Mayfield Phase 1 – EIA Addendum

EIA Addendum

January 2020

Figure 1-3 Modelled Geometry Phase 1 Application 1 in existing surroundings mitigation

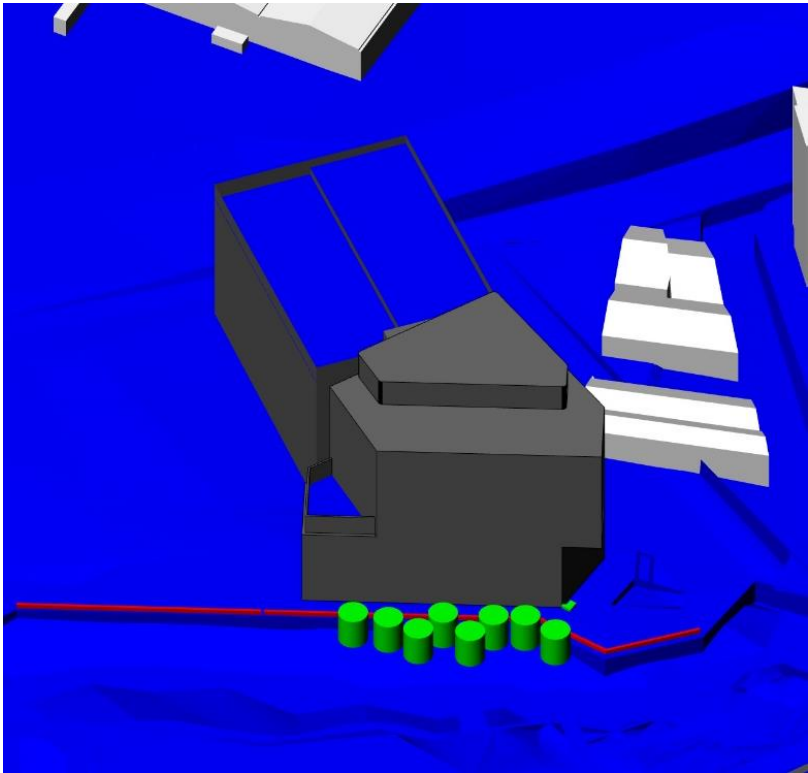
1.3.5 The agreed and tested mitigation for Application 1 is listed in Table 1-1 and shown in Figure 1-3 below.

Figure 1-4 Phase 1 Application 1 in existing surroundings - summer composite comfort map (12 wind directions)

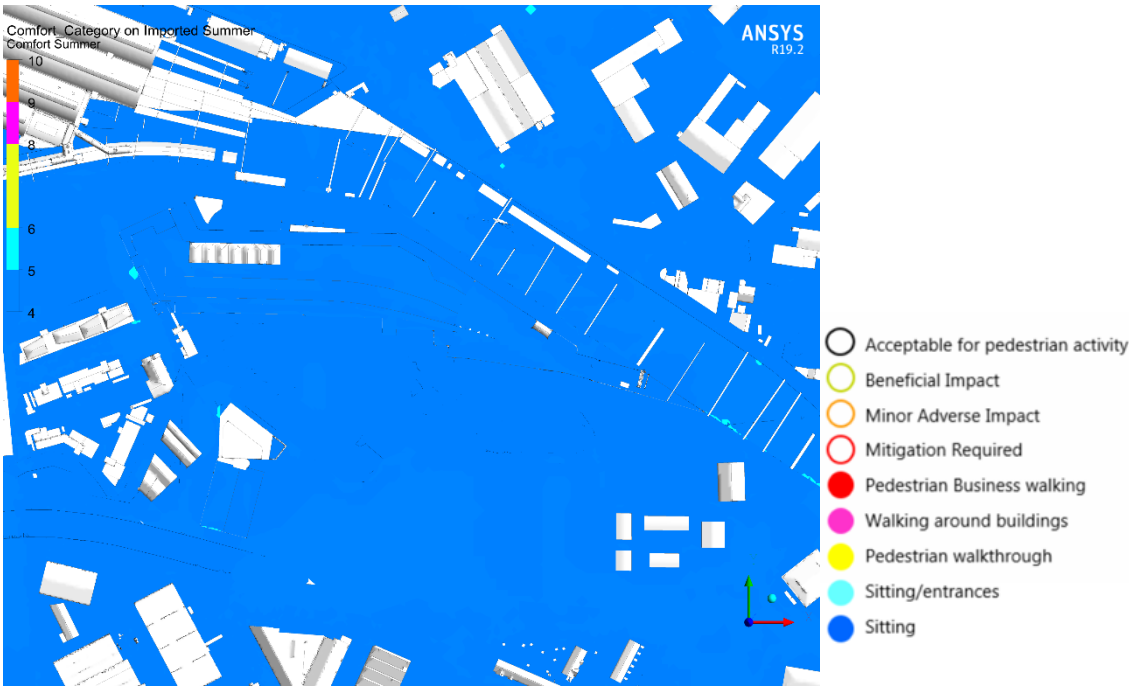
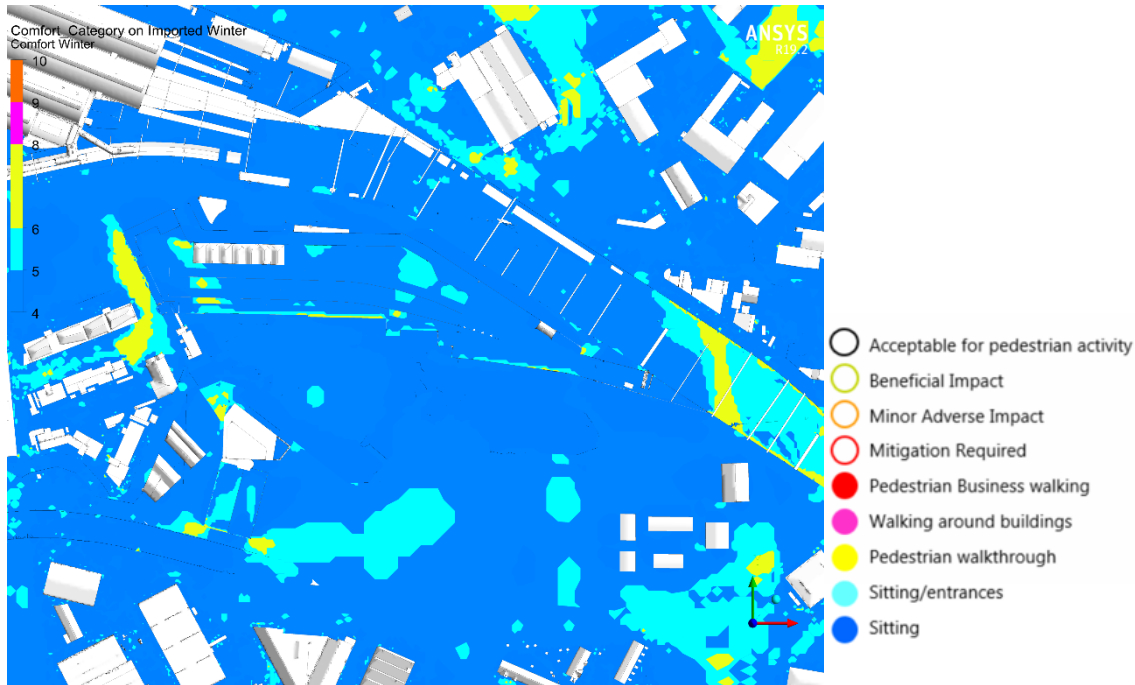
1.3.6 The updated test results show very similar operational effects to those reported in the October 2019 ES. However, a slight reduction to windy areas in yellow (suitable for pedestrian walking) is noticed, mainly produced by the reduction of height of Plot N. In line with the October 2019 ES, no safety concerns have been identified. Conditions for summer and winter for Application 1 wind effects are presented in Figures 1-4 and 1-5 below.

Figure 1-6 Modelled Geometry Phase 1 Application 1 and Application 2 in existing surroundings mitigation

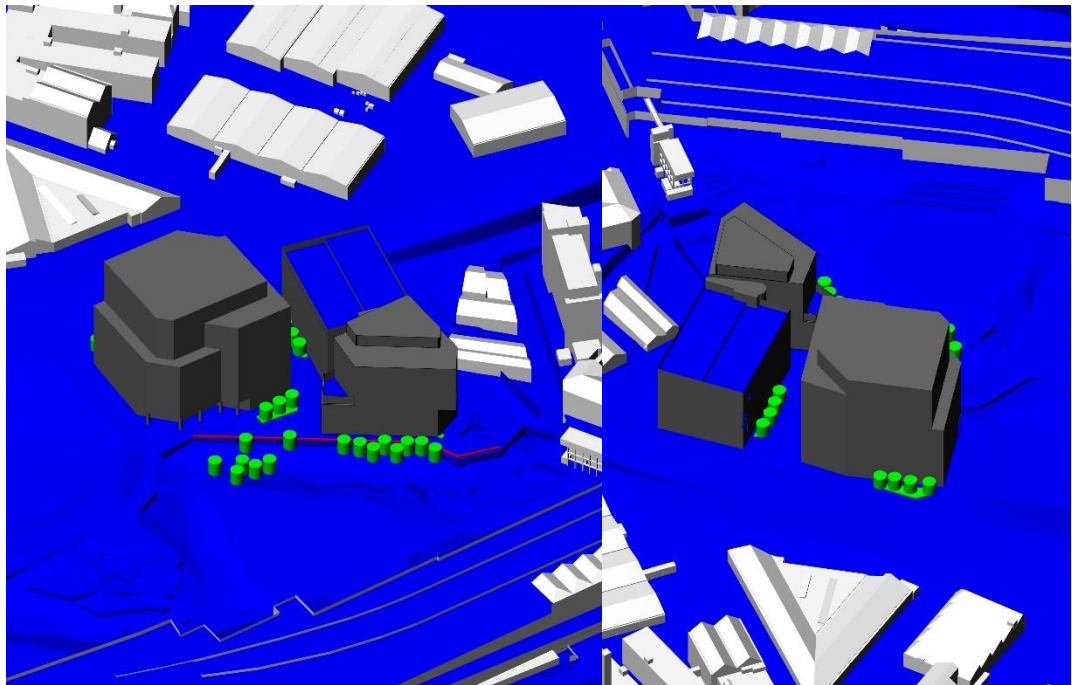
1.3.7 In this scenario there are two main changes in the proposed development from the October 2019 ES; The first one is the reduction of the height of Plot N by 3m, the second is the increase of the height of the cantilever to the north of Plot O. The mitigation strategy remains unchanged from that proposed in the October 2019 ES. The agreed and tested mitigation is listed in Table 1-2 and shown in Figure 1-6 below.

Figure 1-7 Phase 1 Application 1 + Application 2 in existing surroundings - summer composite comfort map (12 wind directions)

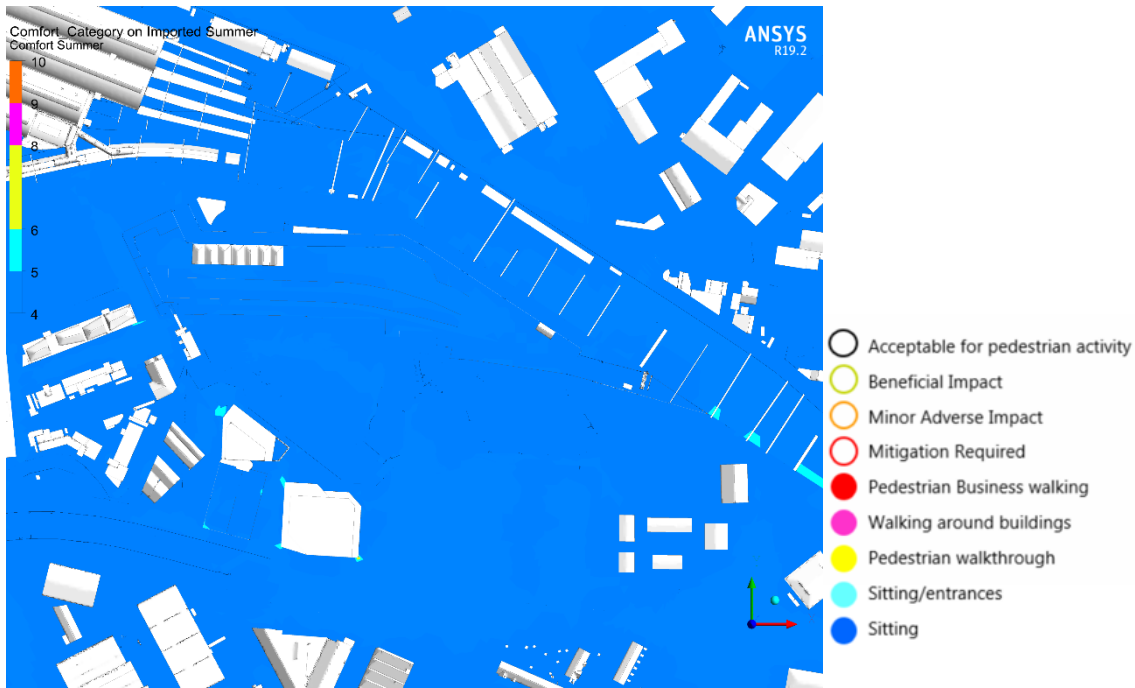
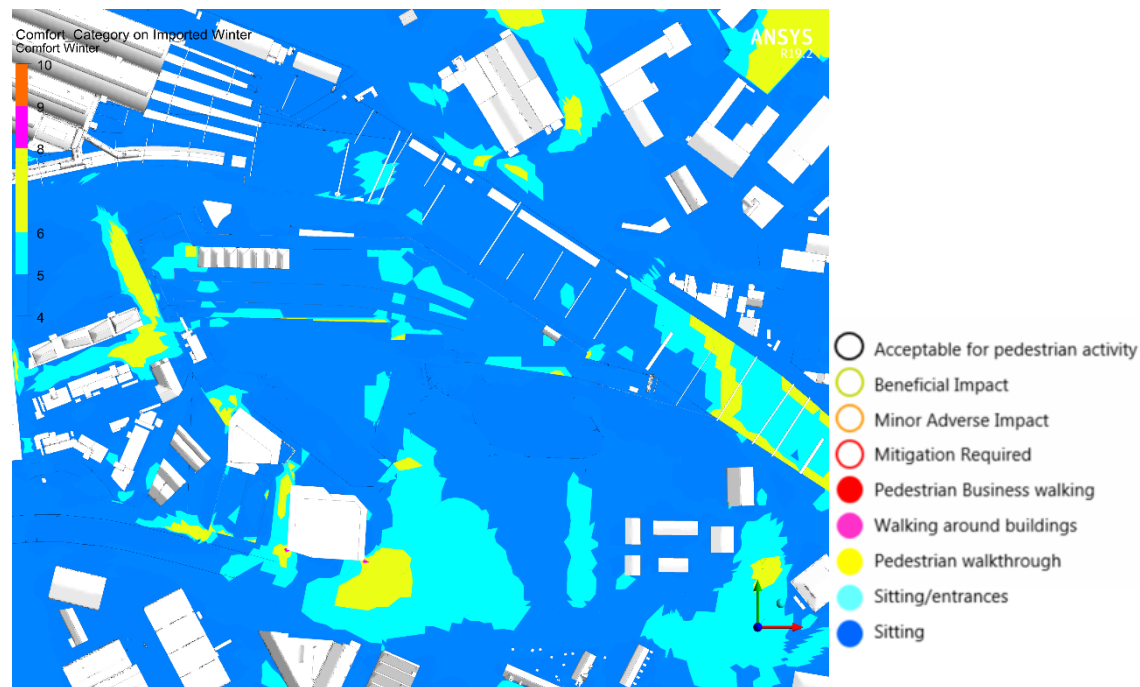
1.3.8 The operational effects remain unchanged from the October 2019 ES. A slight reduction in windy areas is, however, noticed mainly due the height reduction of plot N. In line with the October 2019 ES, no safety concerns have been identified. Conditions for summer and winter for Application 1 and Application 2 wind effects are presented in Figures 1-7 and 1-8 below.
